Council Agenda Report

City Council Meeting
04-26-21
**Item
4.C.**

Subject: Appeal No. 19-010 - Appeal of Planning Commission Resolution No. 19-25 (20238 Piedra Chica Road; Appellants: Colin Drummond; Applicant: Sakahara Allen Architects; Property Owners: Reza Nebavi and Maryam Akbar)

DISCUSSION: The matter is an appeal of the Planning Commission's approval of CDP No. 18-002, an application to construct a 770-square foot addition to an existing single-family residence and other associated development (Attachment D – Project Plans).

Existing OWTS Dispersal Field

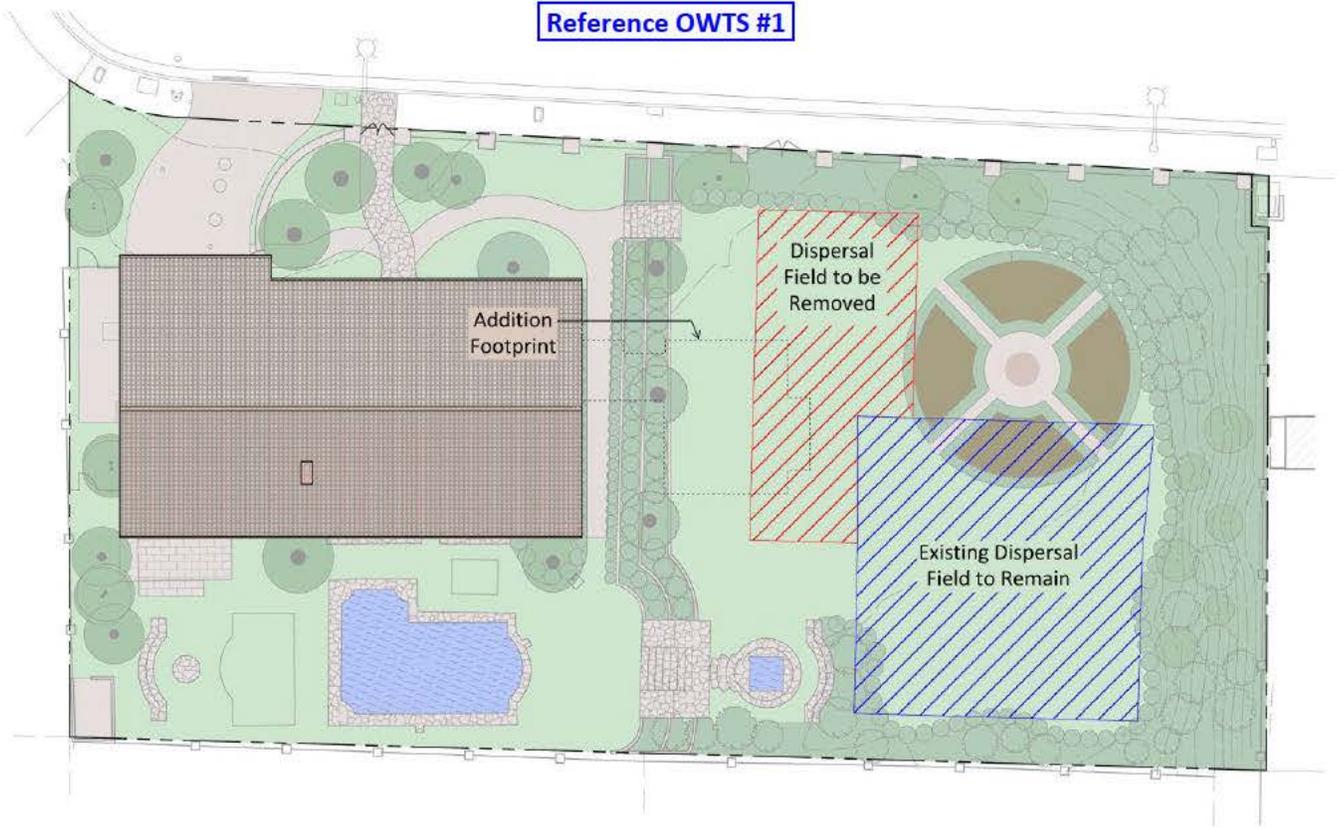
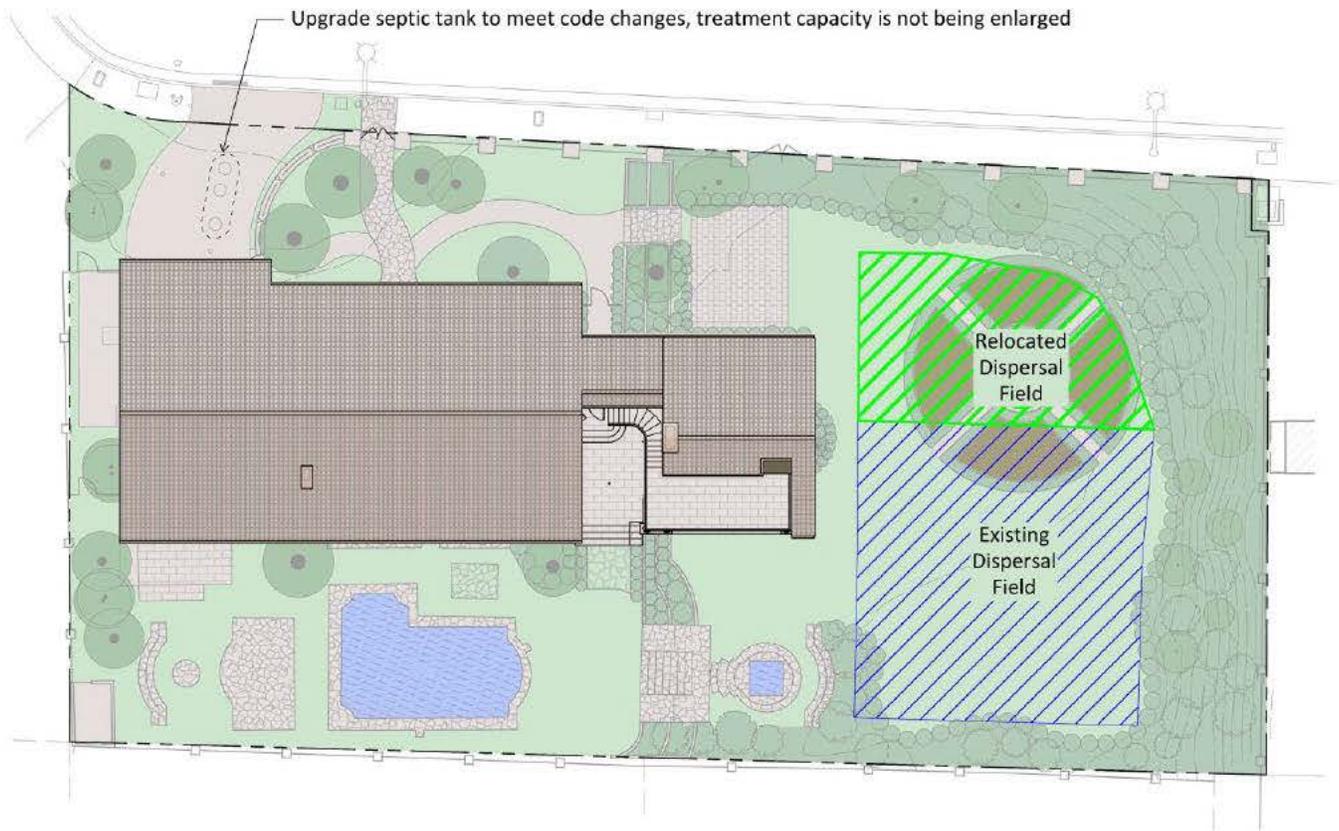
3. Adding TWO extra full bathrooms and laundry, yet proposes a smaller and new location of the EXISTING septic system installed, but huge existing leach field removed - this affects the drainage negatively in our tract also within CC&Rs and should be within your codes A2.2 - no one has ever been allowed to add bathrooms in Big Rock due not being on City water. The water dept are putting in two meters - this is only ONE LOT - how is this allowed? Where is the water and septic being pumped to?

Upgrade septic tank to meet code changes, treatment capacity is not being enlarged

Table of Area Measurements

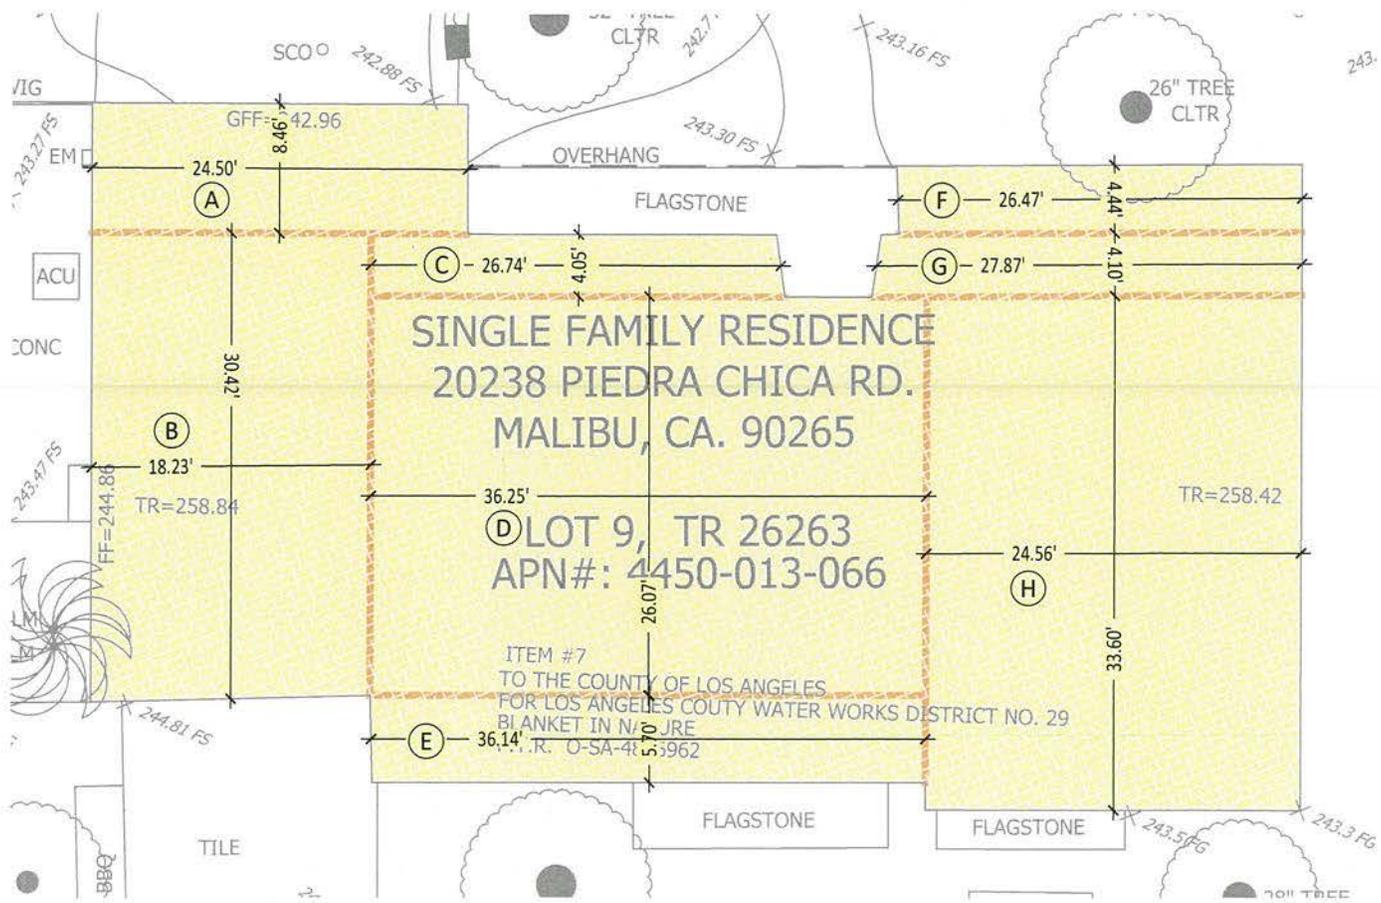
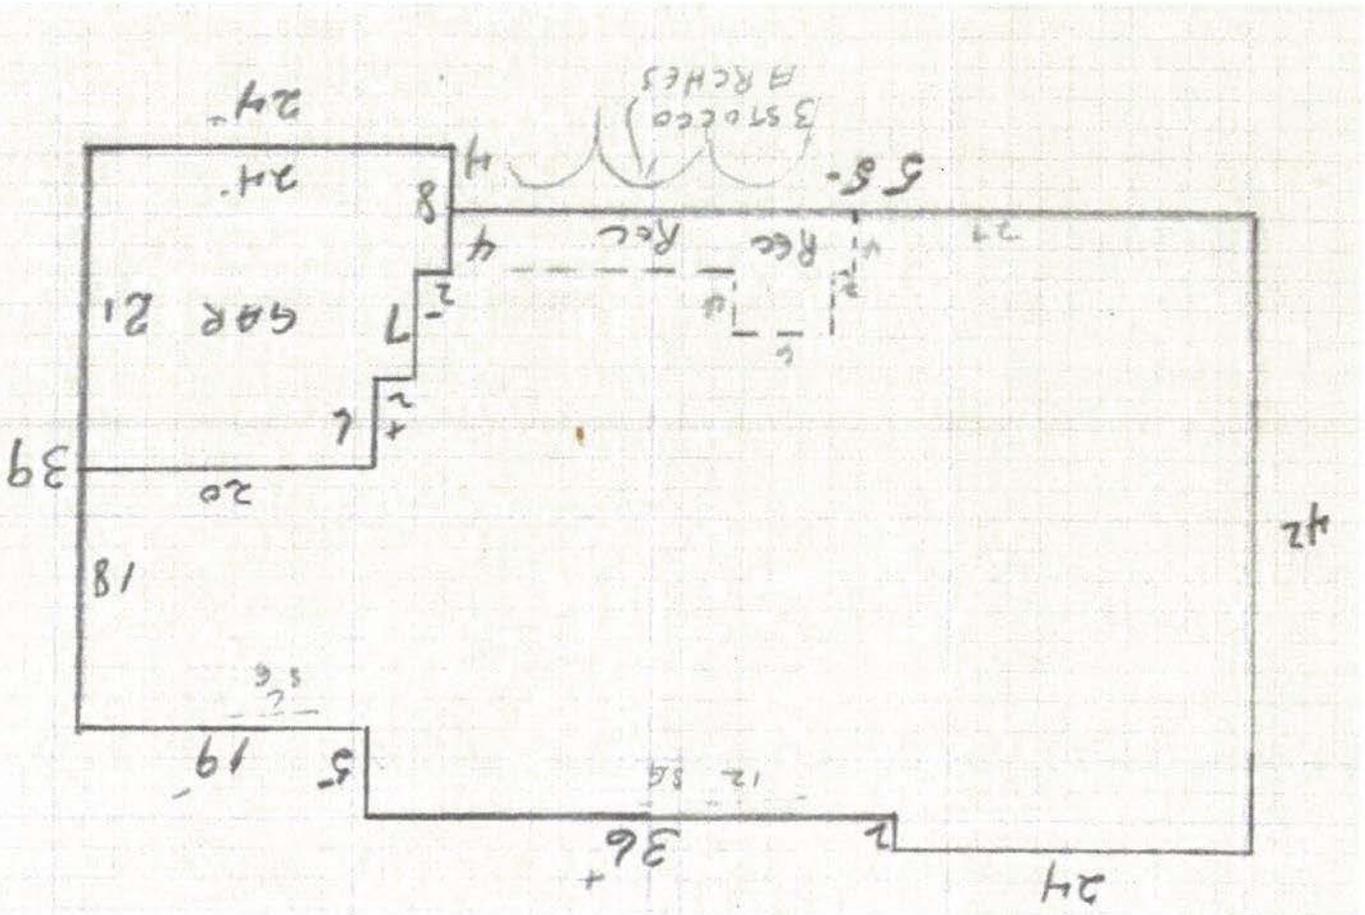
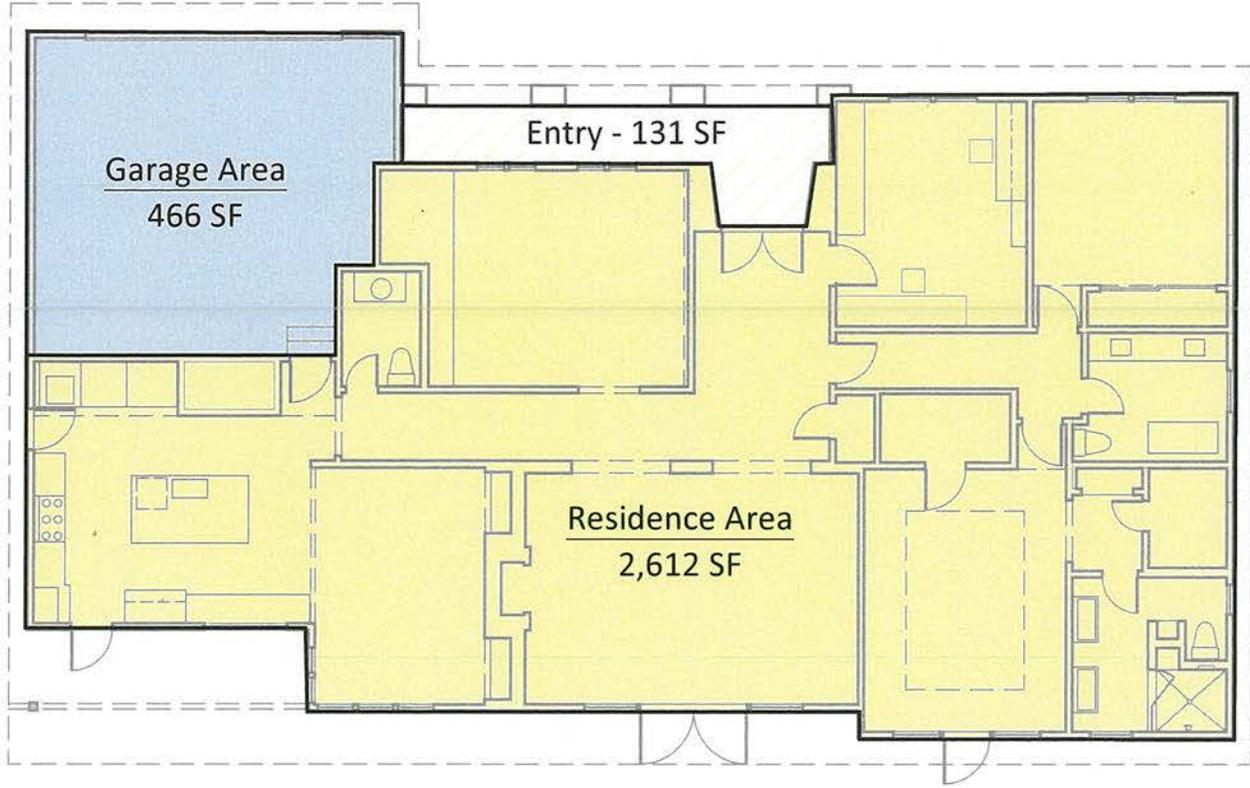
- b) LA County Assessor records from 1/24/1967 provide a measured floor plan and documented residential area of 2,743 SF plus an attached garage of 466 SF, totaling 3,209 SF. Reference Exhibit 3. These records confirm the existing building footprint and gross floor area submitted in the project application are consistent with original building construction & permit. The assessed gross floor area of 3,209 SF is greater than measured survey area of 3,078 SF due to the inclusion of the recessed front entry and porch. Note this larger area is not being used as the basis for 25% addition. For a breakdown of floor areas, see Exhibits 4 & 5.
